North Dakota Department of Transportation

ADDENDUM 1 – JOB 6

TO: All prospective bidders on project SC-2335(056), Job No. 6 scheduled for the November 15, 2013 bid opening.

ADDENDUM 1 JOB 6

Revised 10/28/2013	STATE	PROJECT NO.	SECTION NO.	SHEET NO.
	ND	SC-2335(056)	4	1

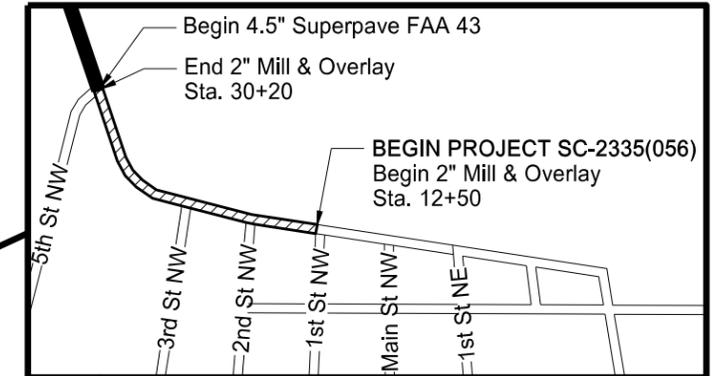
Sheet No. 4-1: Changed project calls to 4.5" Superpave FAA 43.

Revised 10/28/2013	STATE	PROJECT NO.	SECTION NO.	SHEET NO.
	ND	SC-2335(056)	30	1

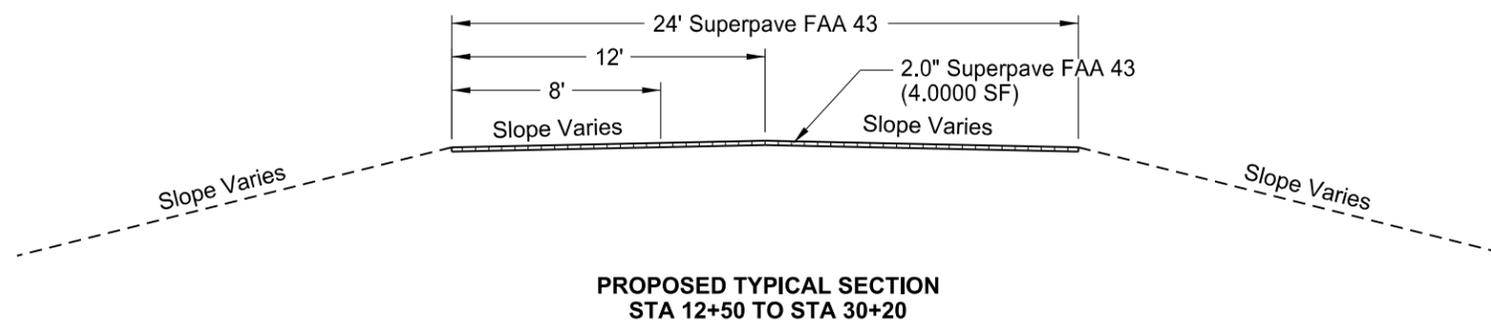
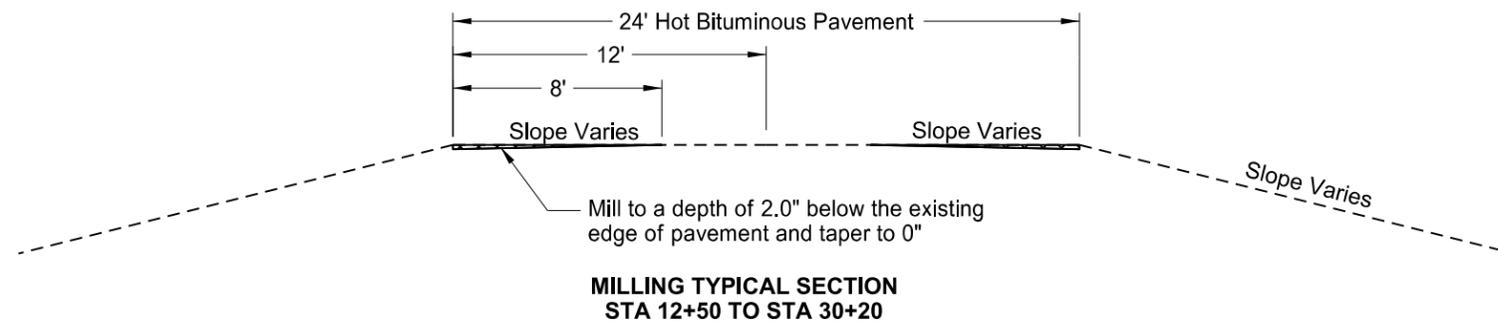
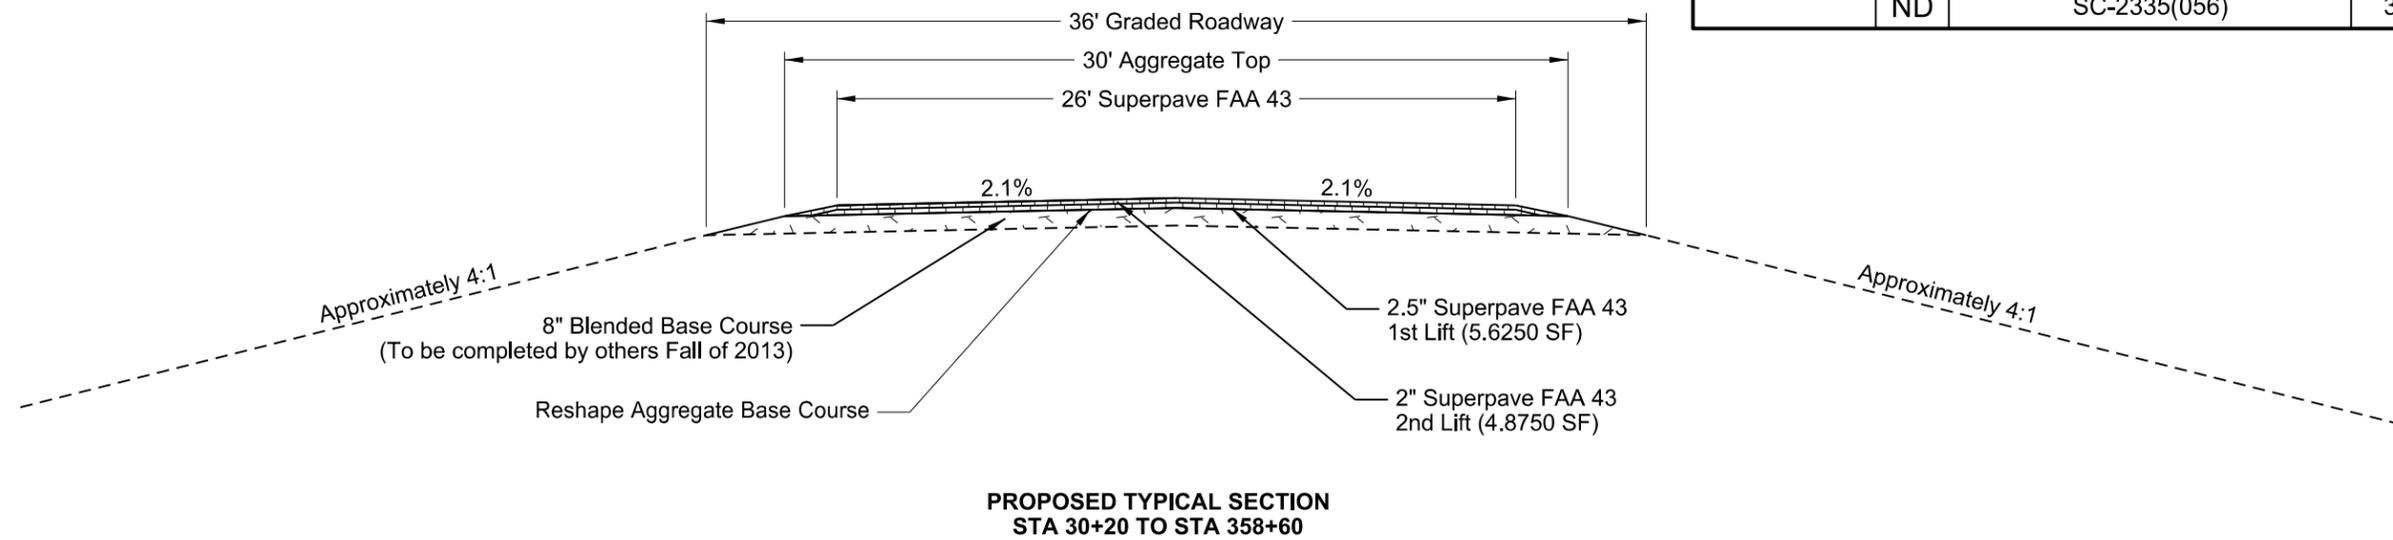
Sheet No. 30-1: All references to Hot Bituminous Pavement CL 29 have been changed to Superpave FAA 43. Pavement thickness for second lift between stations 30+20 and 358+60 has been increased to 2".

Revised	10/28/13	STATE	PROJECT NO.	SECTION NO.	SHEET NO.
		ND	SC-2335(056)	110	2

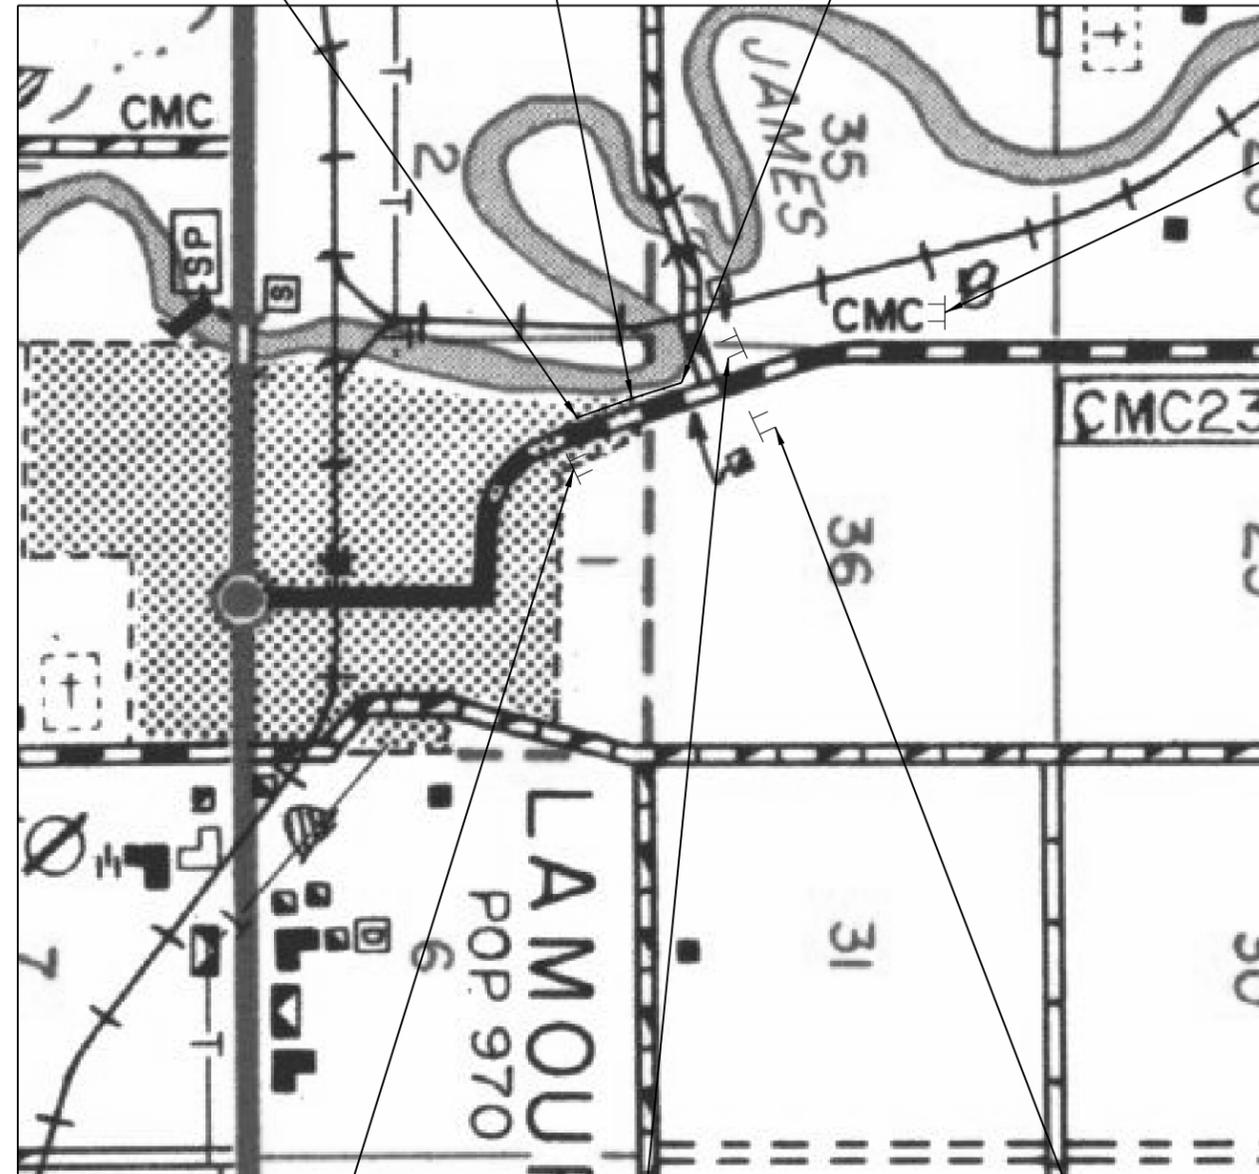
Sheet No. 110-2: W3-5-36 sign at station 58+00 ~ LT has been added. Additionally, a call for installing an intermediate anchor for the guardrail at station 44+78 ~ LT has been added and the speed limit signs at stations 30+50 ~ RT and 50+60 ~ LT have been reduced to 40 MPH.

*Install Intermediate
Anchor at Sta. 44+78

W3-5-36
Sta. 58+00 ~ LT
Assembly No. 20
